TRANE®

Confidential Service Bulletin

Insulated Bearing and Brush Kit

For units with LiquiFlo2.0 drives

Figure 1. Photo of typical spark discharge damage in a bearing race

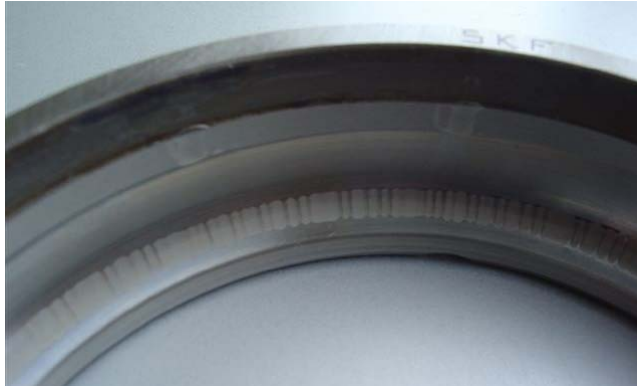
A situation may occur in some LiquiFlo2.0 equipped units where the chiller motor experiences a shaft voltage. The shaft voltage created may seek a path to ground through the thrust bearings, resulting in damage to the thrust bearing.

If a LiquiFlo2.0 AFD equipped chiller with steel bearing BRG01209 is determined to have suffered a premature or repeat thrust bearing failure due to spark discharge, then Trane has available to install an insulated bearing assembly, a new design grounding brush, and a bearing inspection cover that allows the fitting of the new design brush.

For an LiquiFlo2.0 equipped chiller with a standard steel thrust bearing BRG01209 that has failed due to spark discharge, with or without a brush kit: Order and install the insulated bearing assembly, new design brush, and (if needed) a new bearing inspection cover. See the parts ordering information below for details.
